WPJ2 - Replacing Screw Connections on Spring Strut and Transmission Mounts (Workshop Campaign)

Model Line: **718 (982)
911 (992)**

Concerns: **Screw connections on spring strut and transmission mounts**

Action: Replace screw connections on spring strut and/or transmission mounts.

Fastening nuts on front spring strut (shown on 718 (982))

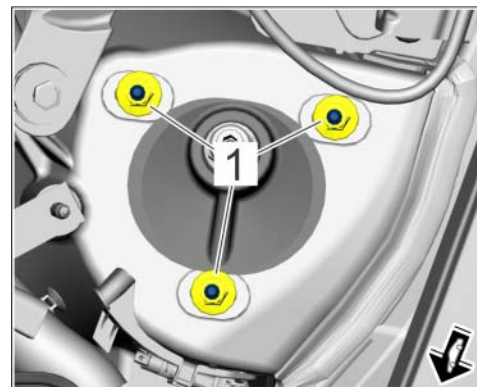
To ensure that the suspension setup does not change, the nuts must be successively replaced and tightened using the specified tightening torque.

- 2 Replace nuts ⇒ *Fastening nuts on front spring strut (shown on 718 (982)) -1* - individually one after the other with **new nuts** ⇒ *Fastening nuts on front spring strut (shown on 718 (982)) -1* - and tighten them.

For 718 (982):
Tightening torque 33 Nm (24.3 ftlb.)

For 911 (992):
Tightening torque 30 Nm (22.1 ftlb.)

Fastening nuts on rear spring strut

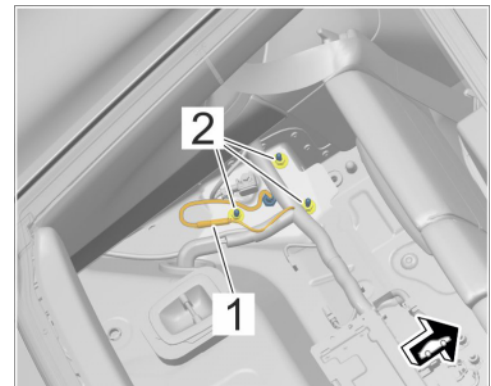
To ensure that the suspension setup does not change, the nuts must be successively replaced and tightened using the specified tightening torque.

2 Replace nuts ⇒ *Fastening nuts on rear spring strut -2-* individually one after the other with **new nuts** ⇒ *Fastening nuts on rear spring strut -2-* and tighten with **Tightening torque 30 Nm (22.1 ftlb.)**.

Fastening nut for transmission mount

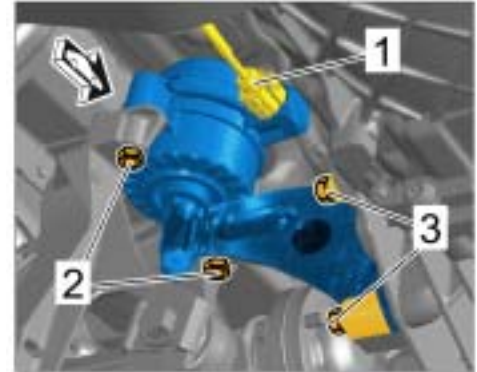
To ensure that the suspension setup does not change, the nuts must be successively replaced and tightened using the specified tightening torque.

- 3 Replace nuts ⇒ *Fastening nut for transmission mount -2-* individually one after the other with **new nuts** ⇒ *Fastening nut for transmission mount -2-* and tighten with **tightening torque 33 Nm (24.3 ftlb.)**.
- 4 **Only for 718 Cayman GT4 (982) or 718 Spyder (982):**
 Install rear underbody cover (rear).
 ⇒ *Workshop Manual '519419 Removing and installing rear underbody cover (rear)'*
- 5 Lower the vehicle and remove it from the lifting platform.
 ⇒ *Workshop Manual '4X00IN Raising the vehicle'*
- 6 Enter the campaign in the Warranty and Maintenance logbook.
- 7 Continue with invoicing **scope 12** or **scope 13**.
